**Re: Commission Investigation Relating to Stray and Contact Voltage  
Occurring in Narragansett Electric Company Territories  
Docket 4237**

The proposed "Contact Voltage Program" filed by National Grid for its operating company, Narragansett Electric Company on August 17, 2012, must be **rejected** to the extent that it proposes to use mobile survey equipment to include "NARDA 8950 Stray Voltage Detection System"<sup>1</sup>. The National Grid Program must be denied or approved only on a condition that the voltage survey detection systems used not include the demonstrably unreliable NARDA model 8950.

**Figure 1 Narda signal strength with substitute structures "Off" is the level of noise produced by the system, vehicle, road vibrations, etc. and is the minimum detectable signal strength, or Noise Floor.**

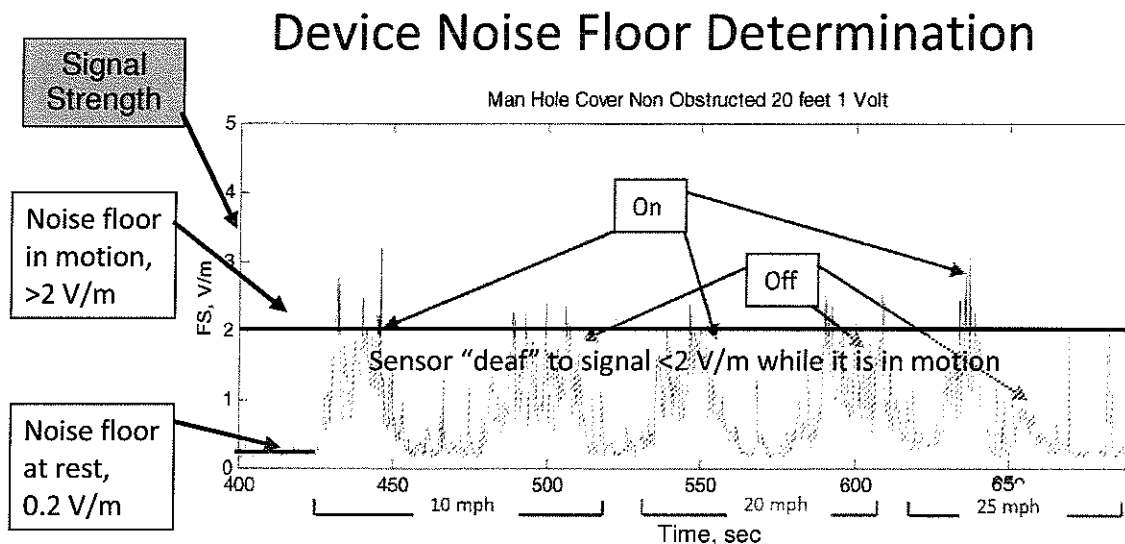
Narda's first test run shows that with no energized structure present, the device returns about 2 V/m. Figure 1, taken from p8 of the test report, illustrates this. The Narda sensor is unable to detect signals smaller than 2V/m while operating at any speed.

In practice, the bulk of the energized objects found in real world distribution systems produce signals in the range of 0.1 to 1 V/m. Only a small percentage of real world energized objects exceed the 2V/m noise floor of the Narda device and are detectable by that device.

**Figure 3 Photo from p 16 of L3 [Narda] test report, showing an array of added electrodes and ground rods added which boost the E-field signal from the substitute structure (Legend added)**

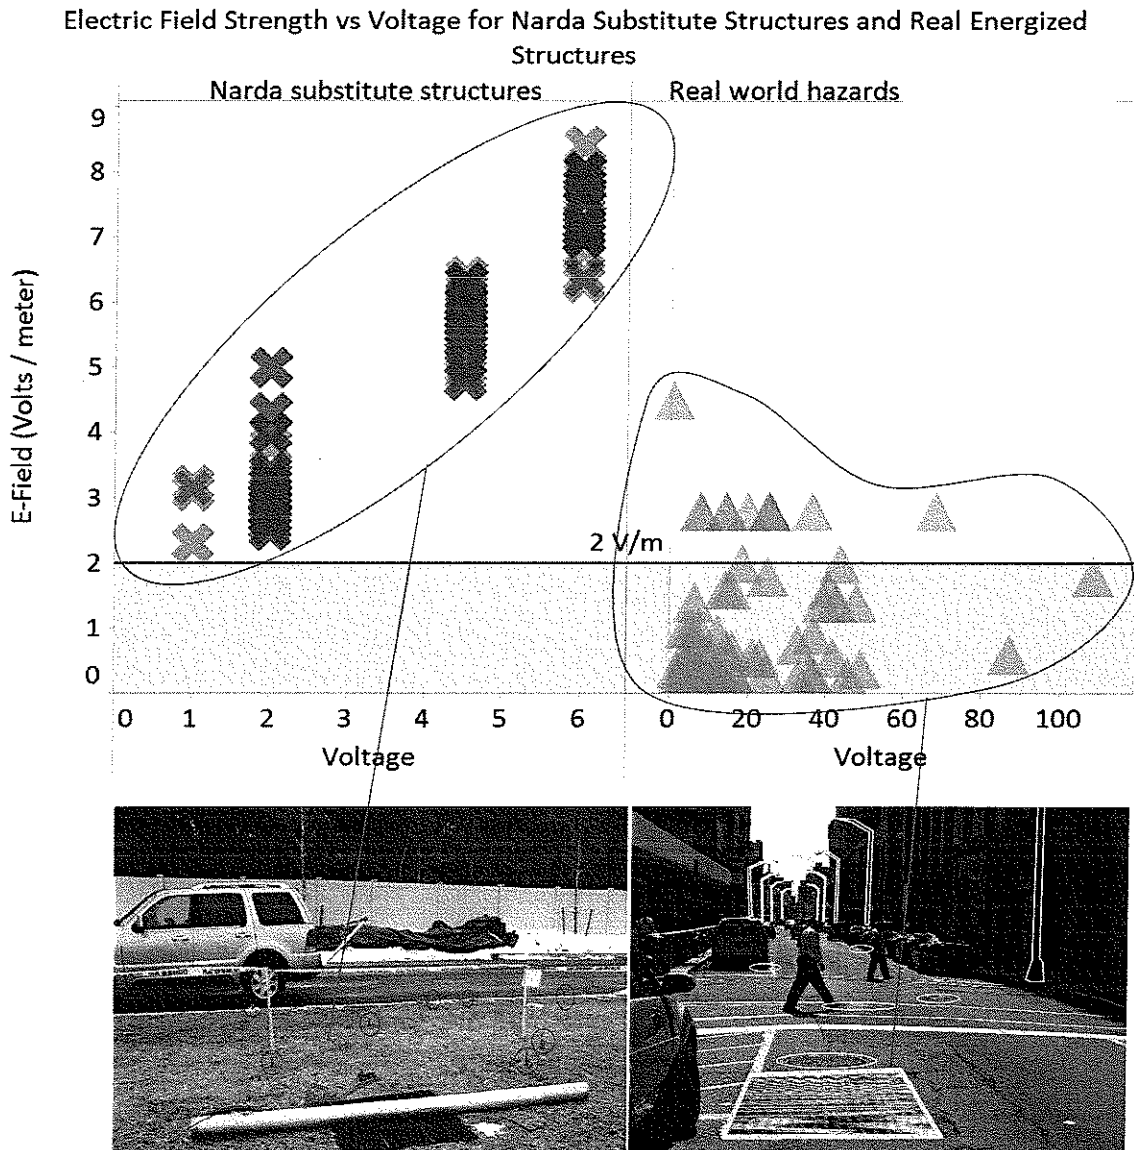
A careful review of the photograph on page 16 of the report (and displayed in Figure 3 below) shows why the signals generated by the substitute structures are far larger than those generated by real world energized structures. The substitute structure in this photo (long pipe), and in fact all substitute structures used during testing, is directly connected (via yellow wire highlighted in blue) to a ground rod driven into the earth. This effectively energizes the earth around it, and boosts the electric field level produced. What's more, Narda installed additional conductors (highlighted in green) and ground rods (circled in red) around the test area and along the curb of the test range in close proximity to the Narda 8950. These are either directly or indirectly energized by the voltage applied to the substitute structure.
